**RESPONSE TO REQUEST FOR FURTHER INFORMATION  
PROPOSED REDEVELOPMENT OF BRISBANE WATER LEGACY SENIORS VILLAGE  
51-57 & 59 MASONS PARADE, POINT FREDERICK NSW**

### Brisbane Water Legacy - Responses to DPIE Request for Additional Information

### **IDG Architects Response to Referrals and Submissions**

### **Proposed Maintenance Shed Plans**

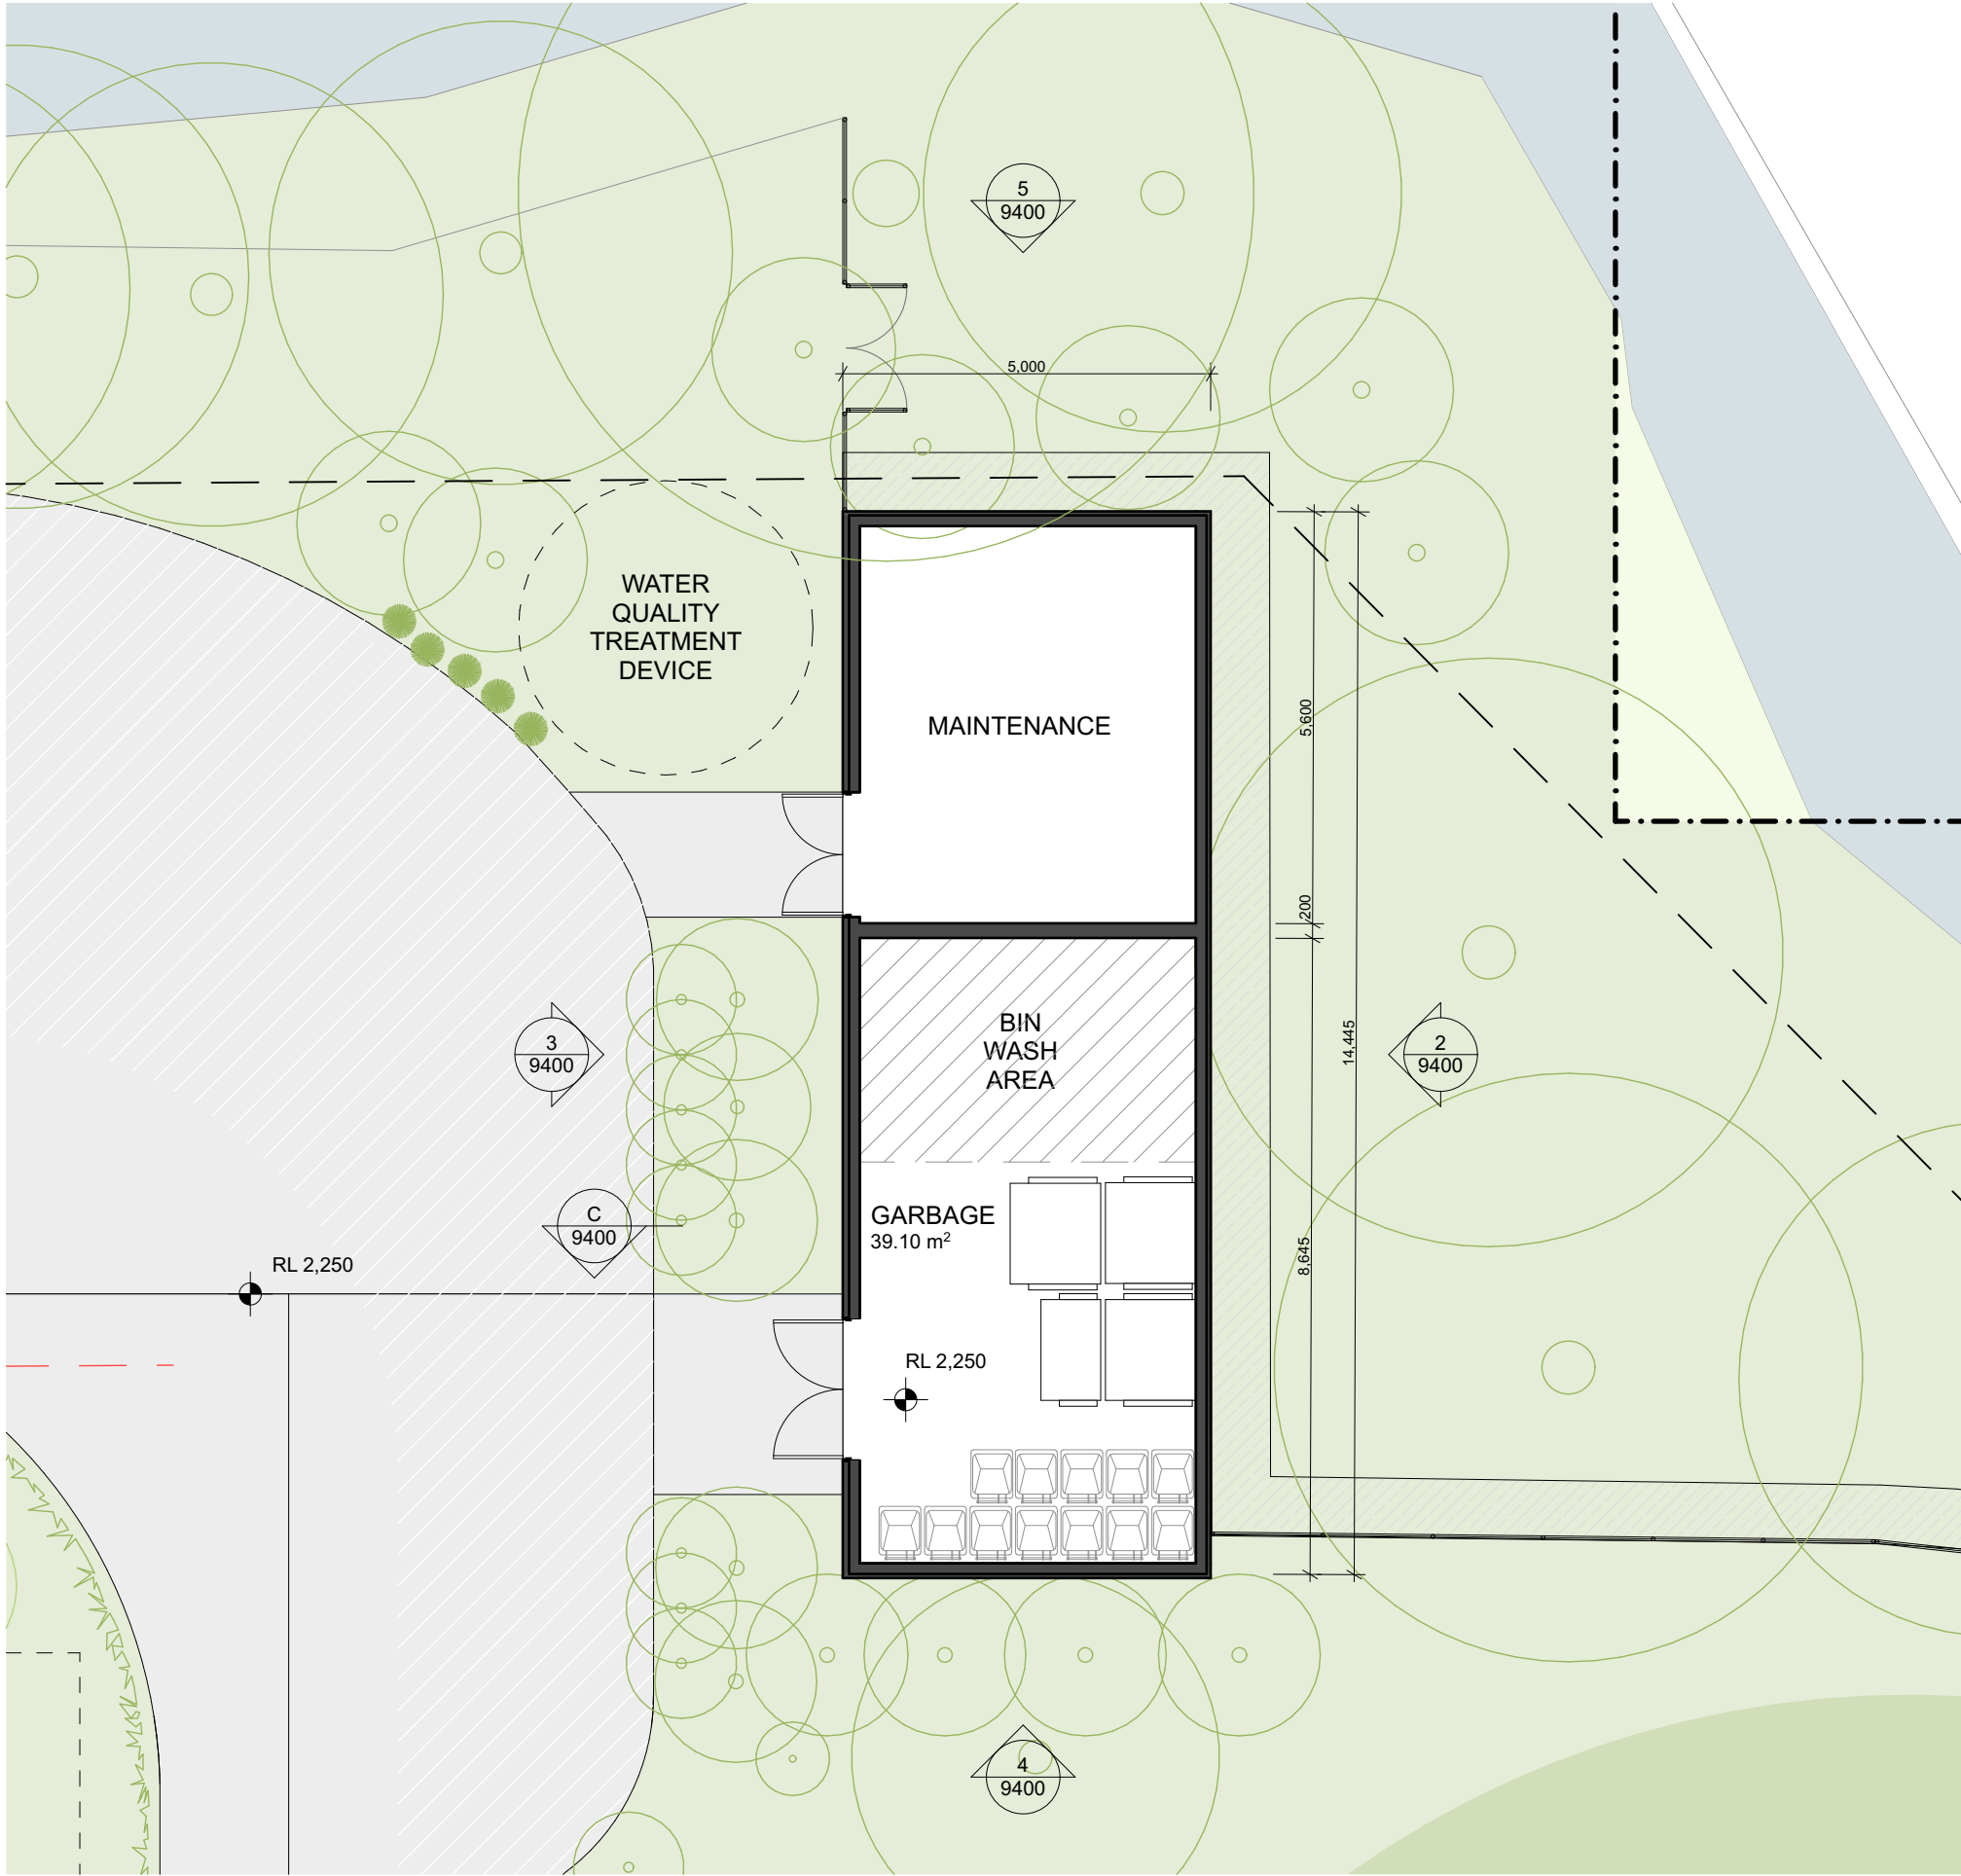
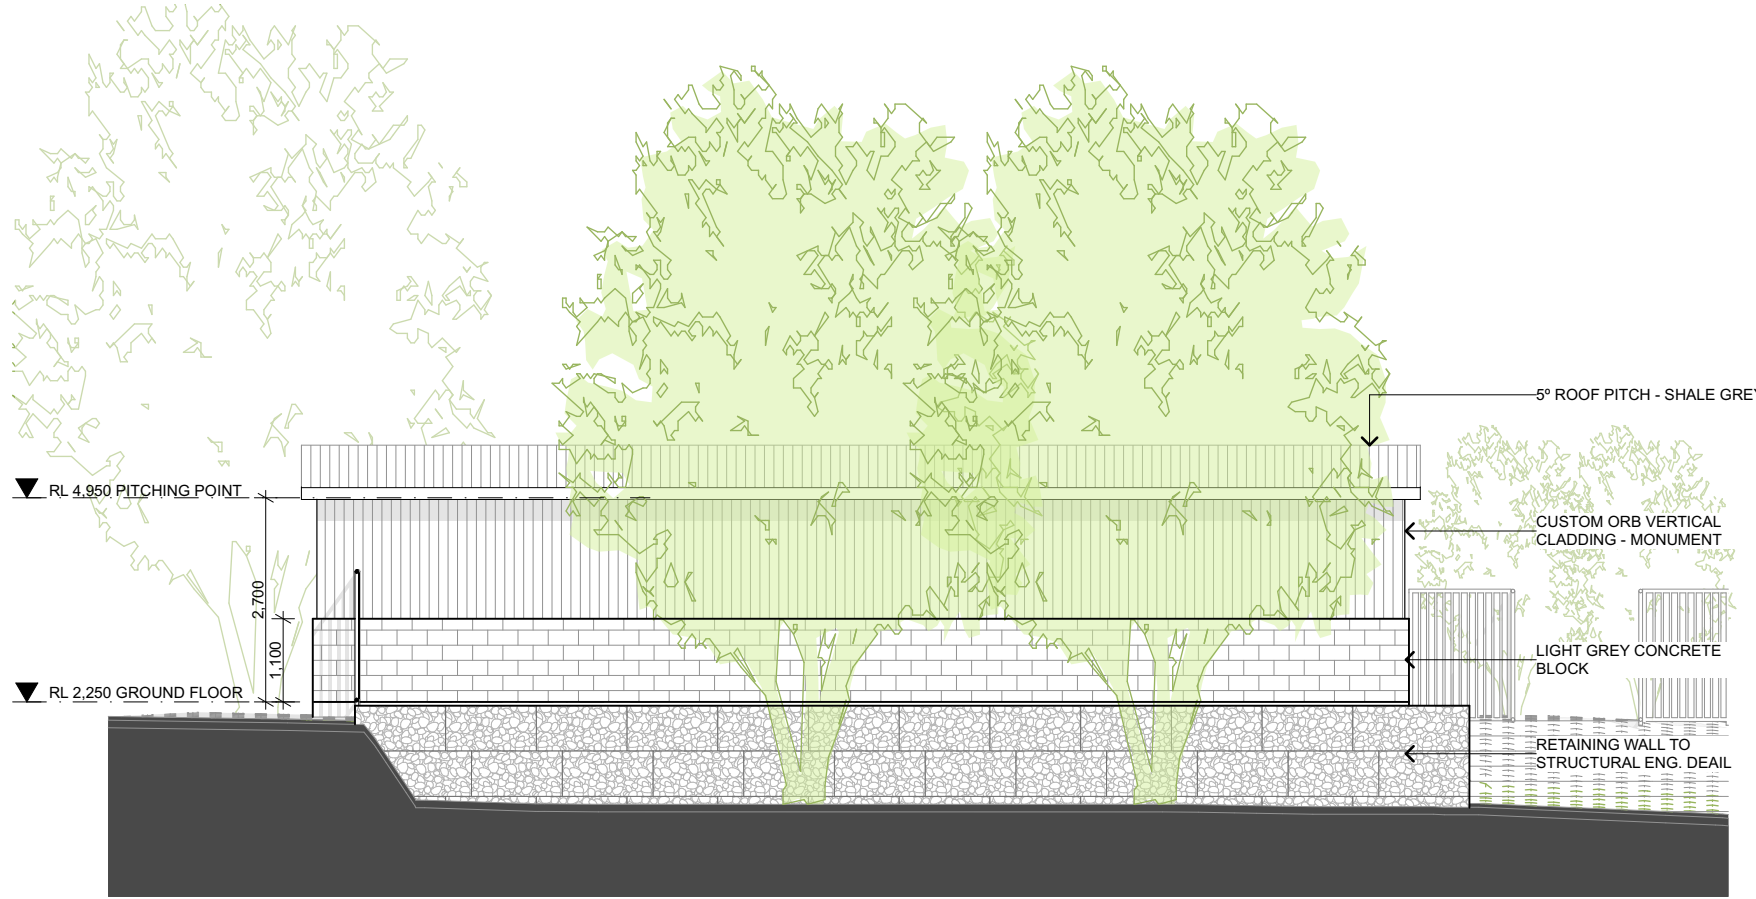
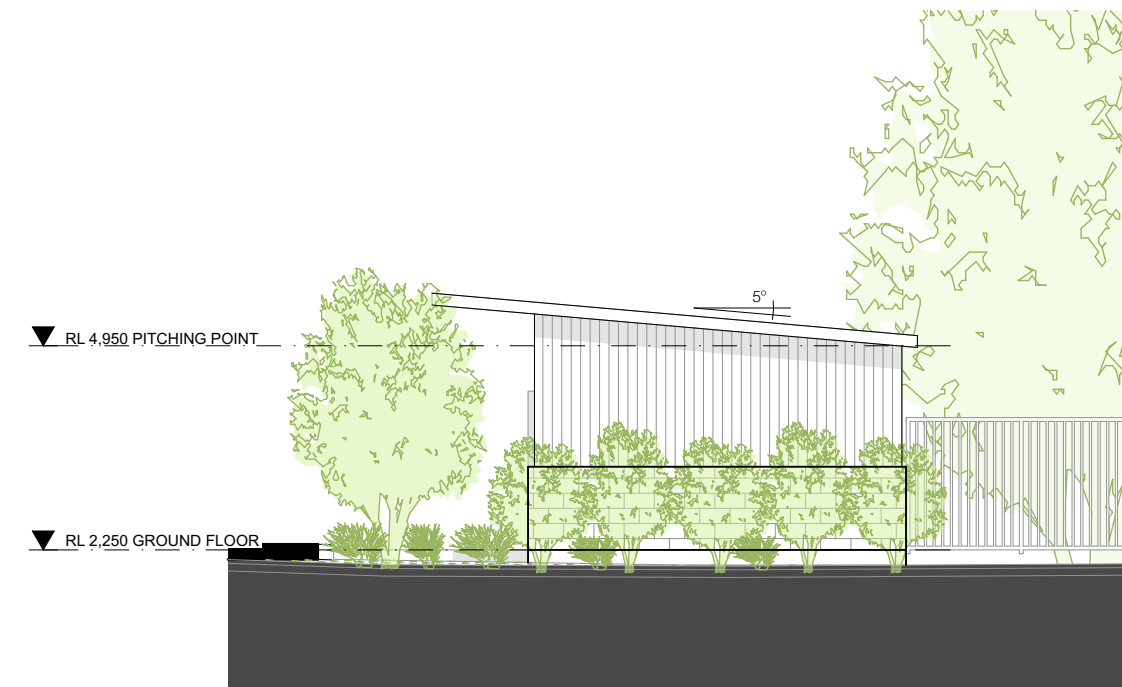
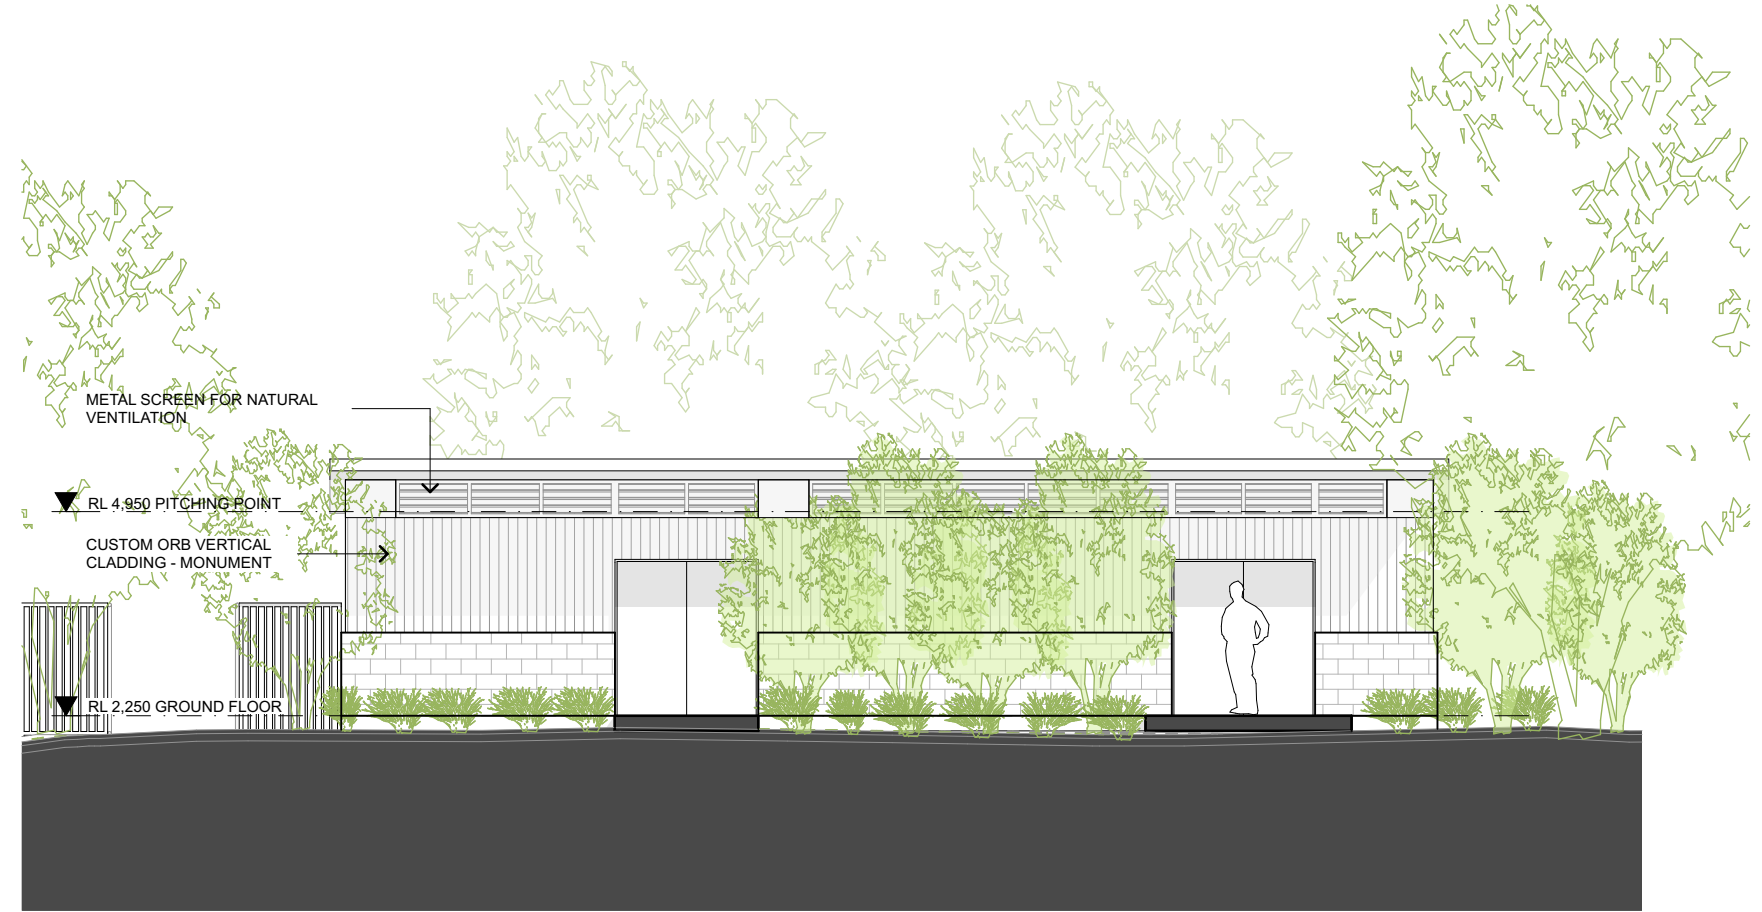
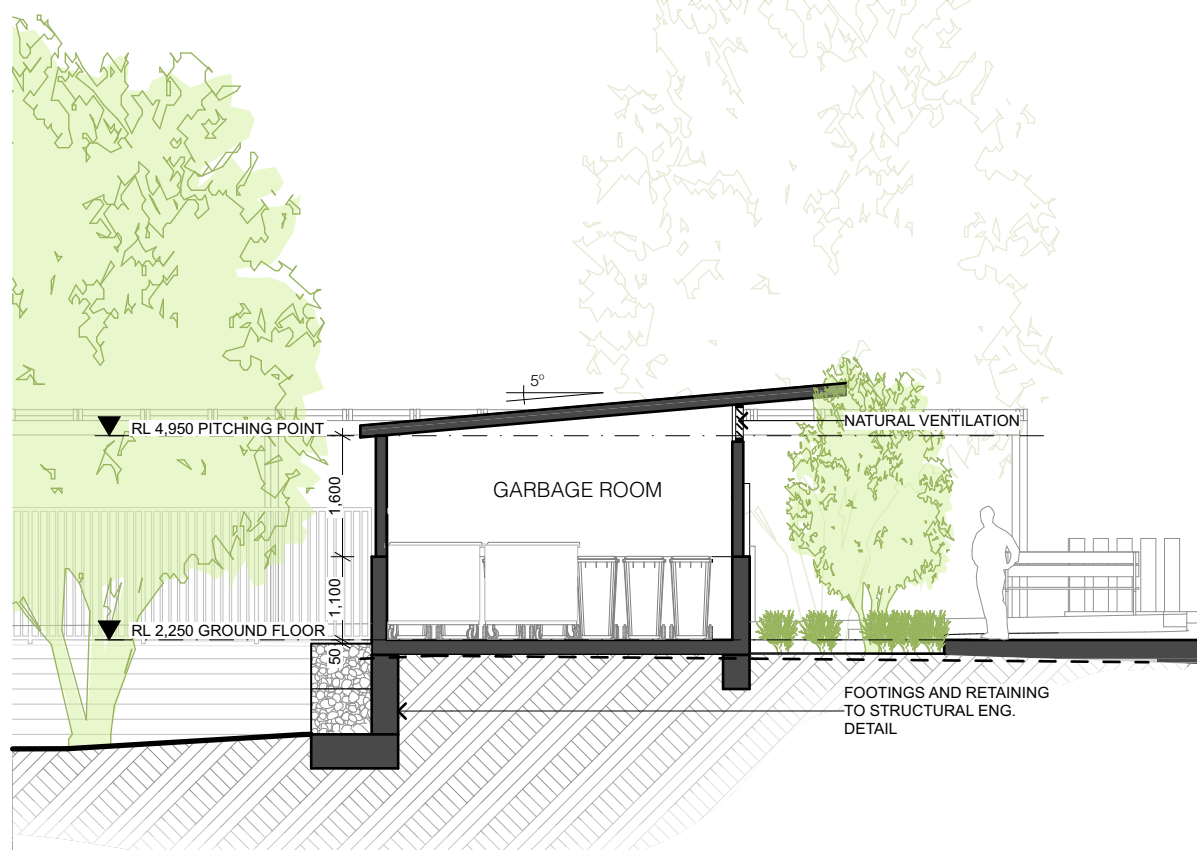
Item	Requested Information	Applicant's Response
	<b>20<sup>th</sup> December 2021 - Regional Assessments</b>	
1	A sun shading resident lounge area is required. Design solutions used in the existing design may be suitable to be used at this location	Refer to drawing DA-3101 Detailed Section a 'hekahood' 900mm wide is proposed - <b>Attachment B</b>
2	Submit detailed sections of the proposed facades to satisfy the State Environmental Planning Policy No 65 – Design Quality of Residential Apartment Development submission requirements under Schedule 2 Forms of the Environmental Planning and Assessment Regulation 2000.	Refer to drawing DA3100, DA-3101 and DA3102 Detailed Sections - <b>Attachment C</b>
3	Submit additional drawings, including elevations, for the maintenance and garbage storage building.	Refer to drawing DA 9400 Maintenance shed - <b>Attachment D</b>
	<b>27<sup>th</sup> January 2022 - Transport for NSW</b>

Maintenance staff will handle all bin movements through the site to the waste storage room. Details have been provided that show the proposed materials and elevations of the waste storage / maintenance shed. Refer to architectural drawing DA-9400 and the UFD Waste Management Report dated 22 September 2021.

The proposed materials are a dark colour so that they disappear within the landscape.

**Image 2 – typical floor plan – bin locations**

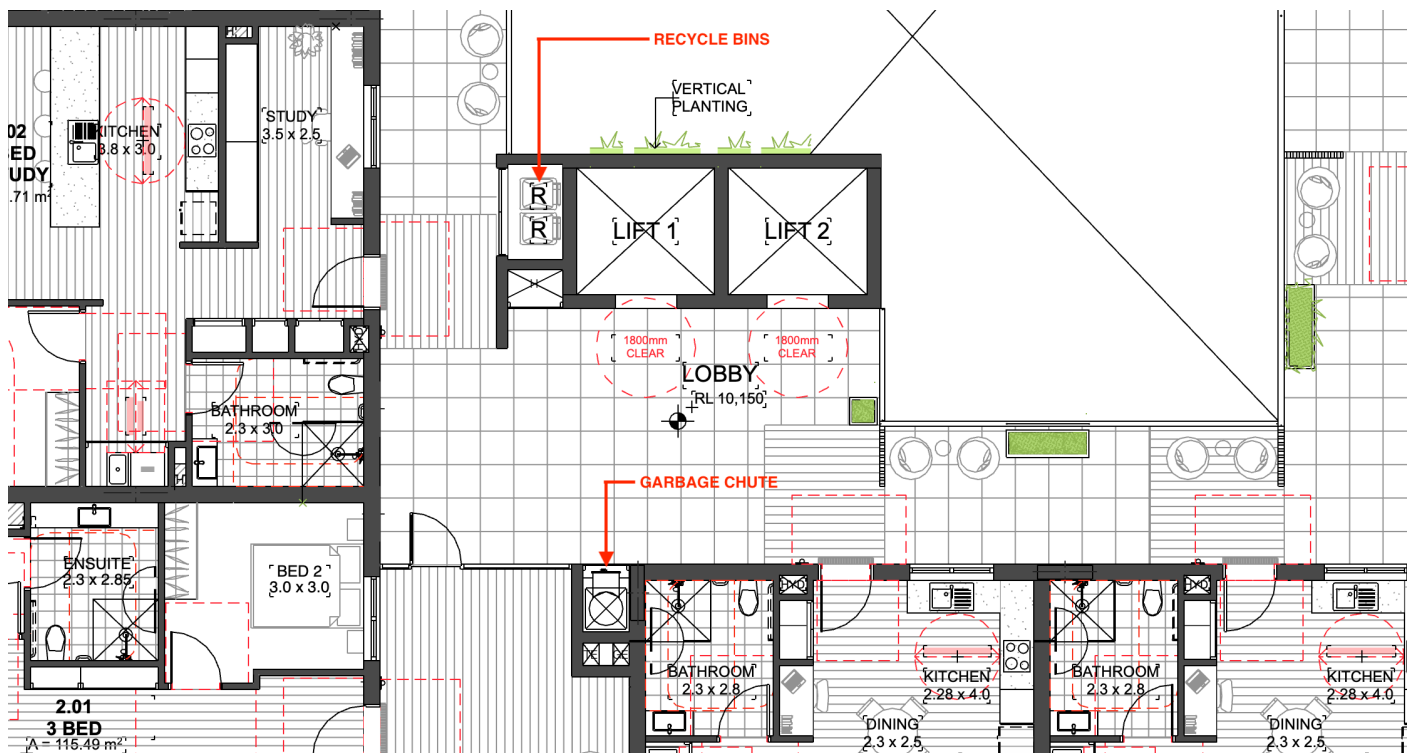
#### Item 4 – Waste Storage Room

Dedicated recycling bin areas are located on each floor near the lift, along with a dedicated garbage chute. Refer to image 2.

**Image 3 – Relationship with Streetscape Rhythm**

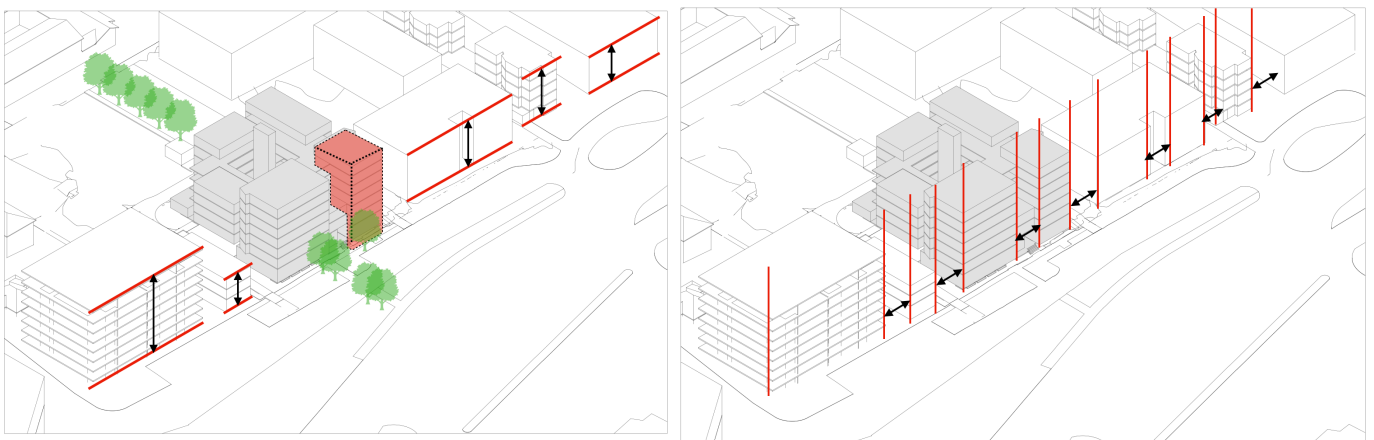
## Item 7

Refer to page 17 & 18 of the Urban Design Analysis report.

As outlined in the Gosford City Centre DCP 2018, the site is to have a primary active street frontage and is to avoid a continuous built edge. The resulting design therefore adopts the rhythmical separation which breaks down the building forms along the street frontage, avoiding a continuous horizontal bulk along the streetscape. These breaks visually reduce the mass of the consolidated development and allow for visual connections between forms to the natural setting of Brisbane Water, which promotes a visual connection to the public open space along the water's edge, whilst also offering strong passive surveillance of the public domain.
